**CAPITOL ZONING DISTRICT COMMISSION**  
**STAFF REPORT**  
**8/24/2016**  
**TDM / BIM**

**Location:** West side of the 1300 block of South Scott Street  
**Applicant:** Frank Barksdale for Tommy Lasiter  
**Permit Types:** Certificate of Appropriateness & Conditional Use

**Project Description:** This application is for a Certificate of Appropriateness permit to allow the construction of a new, three-story apartment building, and for a Conditional Use Permit to use the property as multifamily residential. The two proposed buildings will include a total of 35 units: 11 with two bedrooms and 24 one-bedroom units. The three story buildings feature a mixture of brick veneer and Hardie lap siding on the first two floors and a mansard roof for the top floor. ~~An approximately 25' long covered walkway will connect the two buildings at each level~~ and a gable roof covered with architectural shingles. The windows will be vinyl with simulated divided glass. The proposal calls for a 14' setback on the Scott Street side, 25' setbacks facing 13<sup>th</sup> Street and Daisy L Gatson Bates Drive, and a 26' setback on the alley side. Parking and a dumpster enclosure will be accessed from the

Site Plan (See updated version on Page 23)

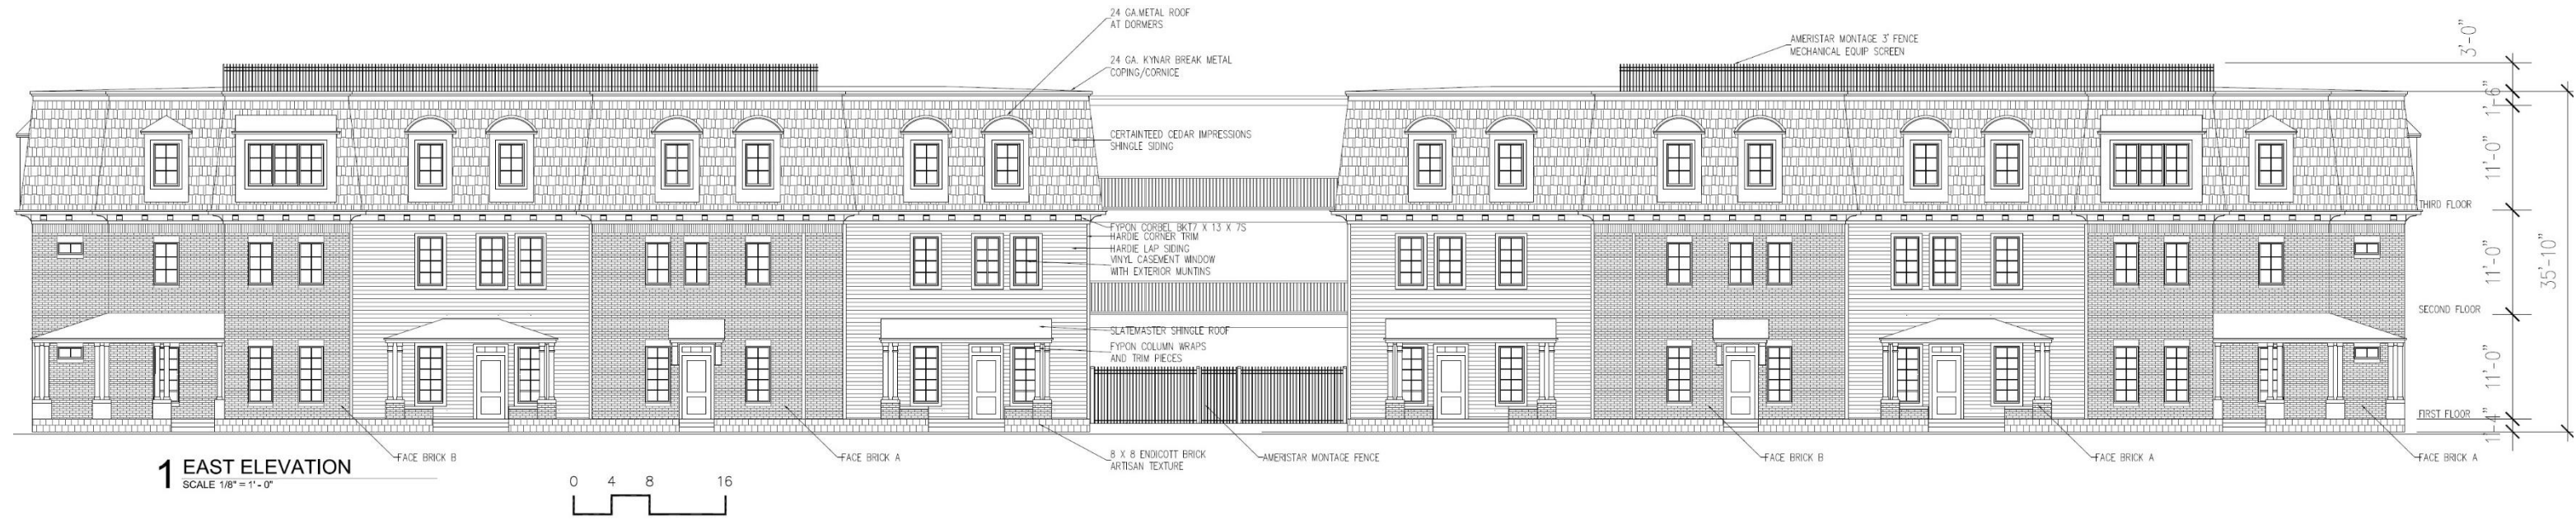
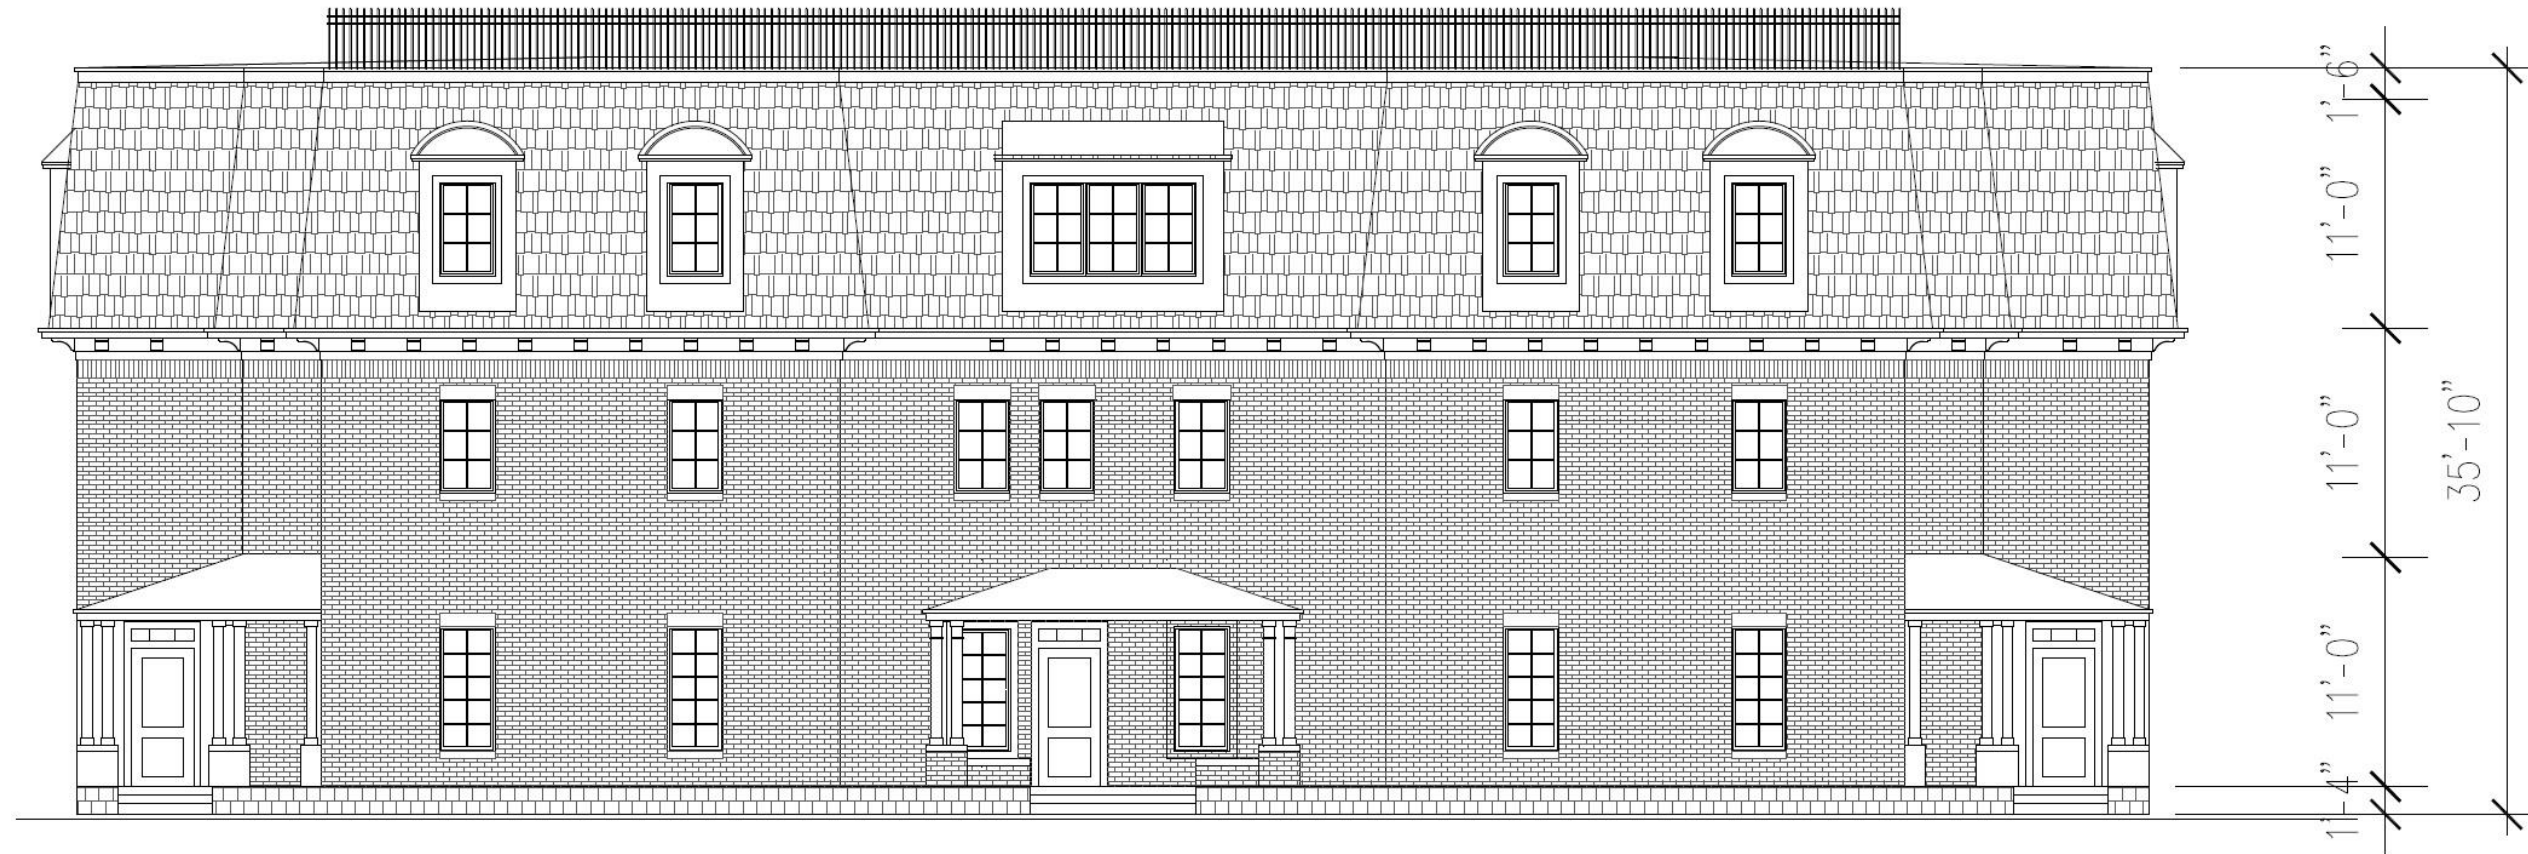
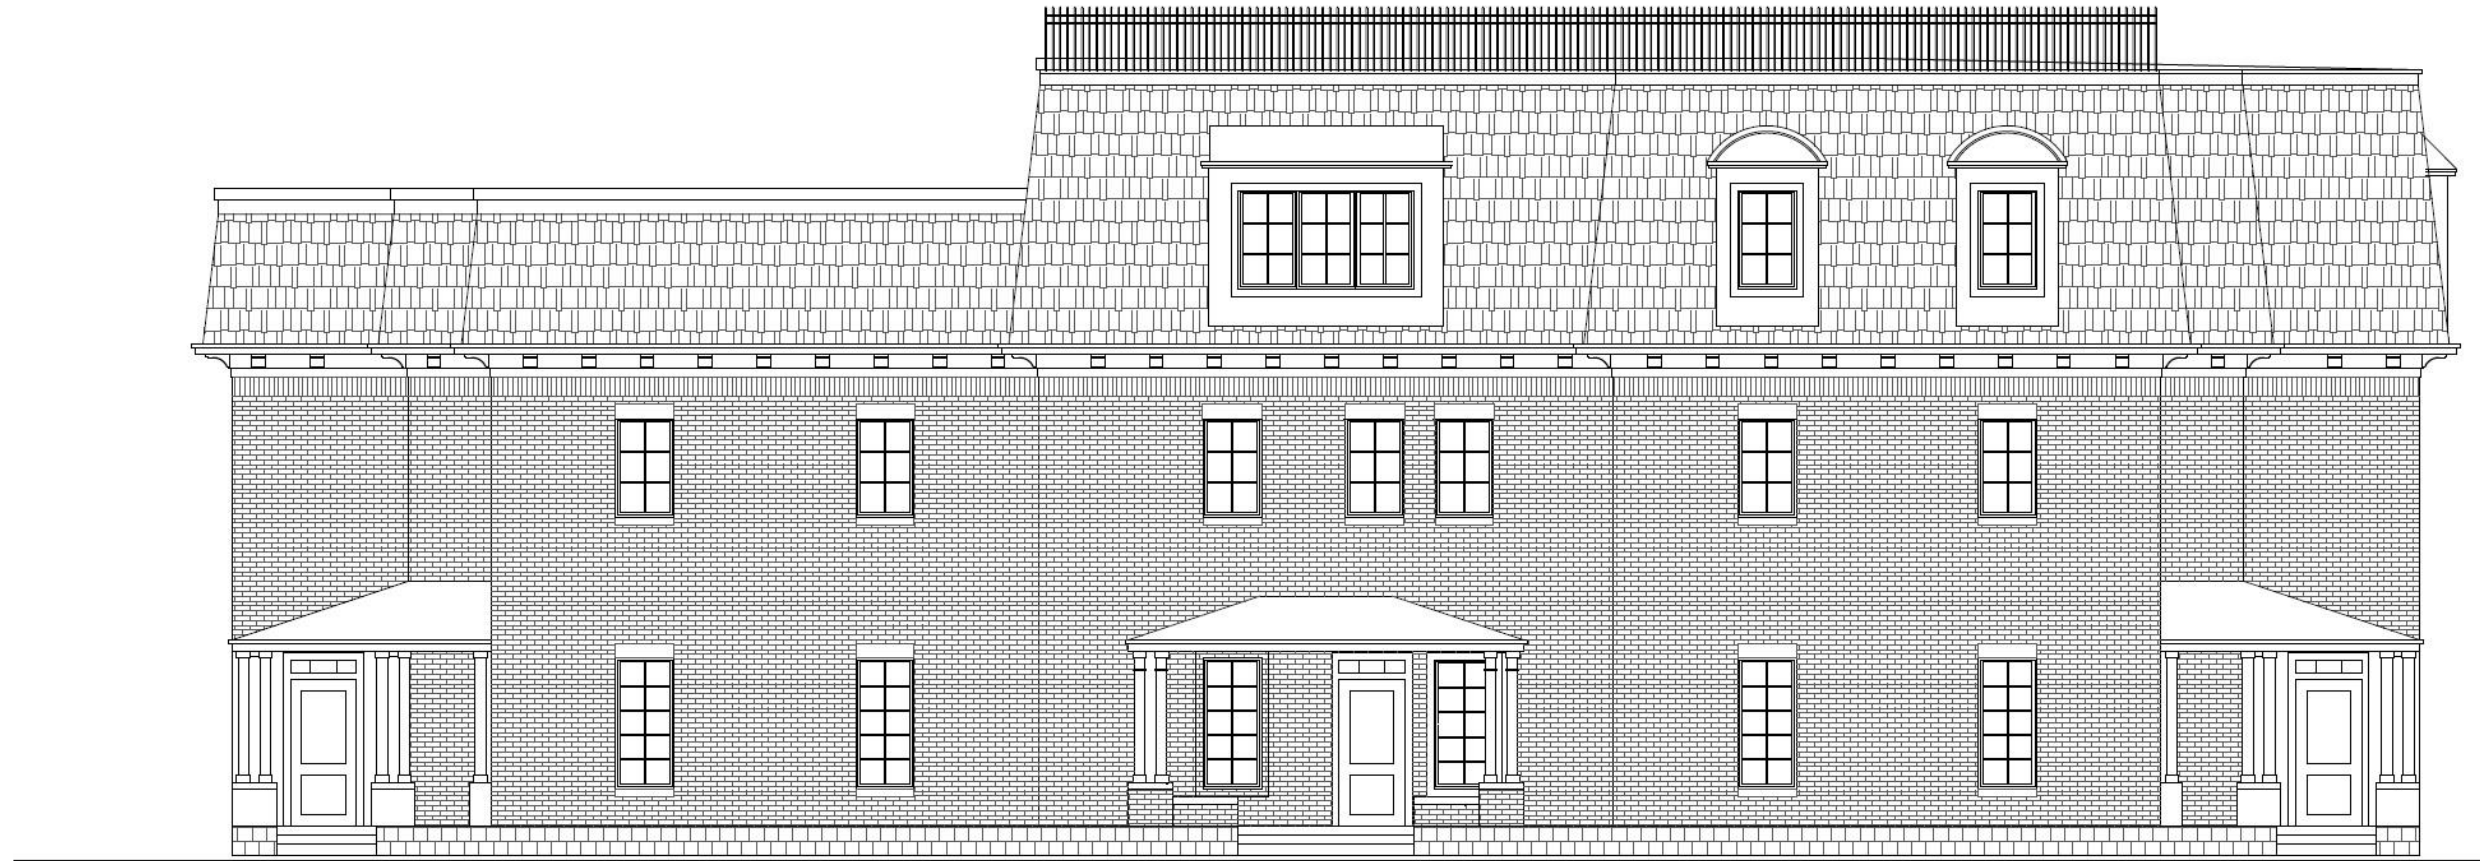
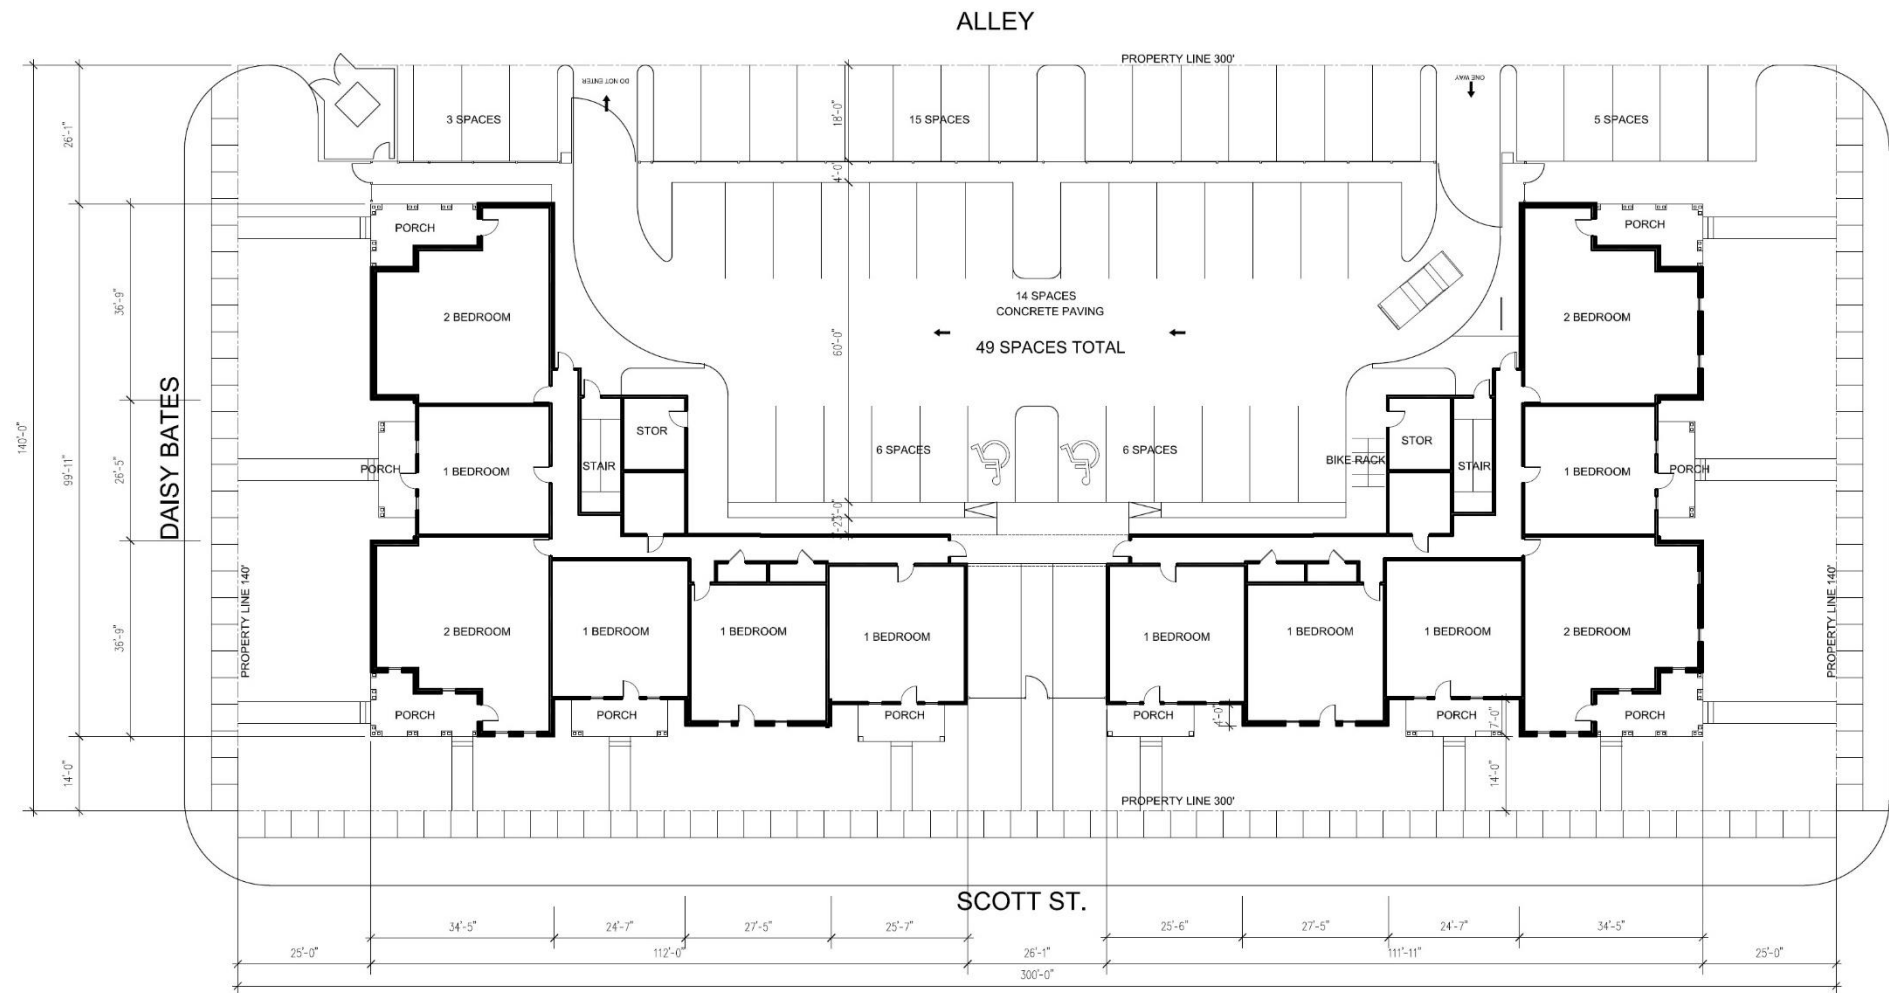
*Staff finds the proposal to be consistent with these requirements. The north and south sides of the lot facing 13<sup>th</sup> and Daisy L Gatson Bates Drive are front yards according to the definition above. The site plan shows a compliant 25' setback on the north and south sides, a 14' setback (10% of 140') on the Scott Street side, and a 26'-1" setback to the alley. The building floor area is 31,264 gross square feet for a F.A.R. of 0.74:1, well below the maximum allowed 1.5:1. The three story building will be 35'-10" high with a 3' mechanical equipment screen, also well below the maximum allowed 45'.*

*Staff finds the proposal to be not mostly consistent with these requirements. The proposed structure will contain 11 two-bedroom units and 24 one-bedroom units, necessitating 40.5 off-street parking spaces. (11 x 1.5 + 24 = 40.5) The site plan proposes 49 46 spaces and associated driveways, or 120% 114% of the required amount of parking. See recommendations below for reducing the number of spaces. Staff finds that the proposed site layout screens most of the parking lot from view from nearby streets and that the extensive landscaping mitigates the larger parking lot.*

*Staff finds the proposal to be incomplete regarding this requirement. Though the site plan shows the location of proposed landscaping, it does not include sufficient details. See conditions 1 and 3 under Staff Recommendation.*

- 1) That all state and city codes be followed at all times;
- 2) That the property be maintained in a neat and safe condition at all times;
- 3) That the parking lot size be reduced by five spaces for a total of 44 spaces and that an updated site plan be submitted to staff;

- 4) ~~That the dumpster enclosure be moved to the north so that it is completely behind the façade of the main building facing Daisy L. Gatson Bates Drive (into the space created by eliminating three of the parking spaces in condition #3 above); (condition met in most recent site plan submission)~~

- 5) That the dumpster enclosure ~~be enlarged to~~ include space for a recycling dumpster or bins;
- 6) That the parking lot landscaping be approved by the City of Little Rock prior to staff issuing the permit;
